Note

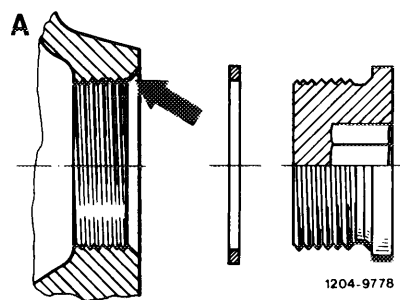
As of October 1980, the modified screw plug M 38 x 1.5 is installed together with an O-ring.

The chamfer in the crankcase was changed for this reason (2nd version).

When installing a coolant preheater, an O-ring or sealing ring to suit the chamfer in the crankcase should be used.
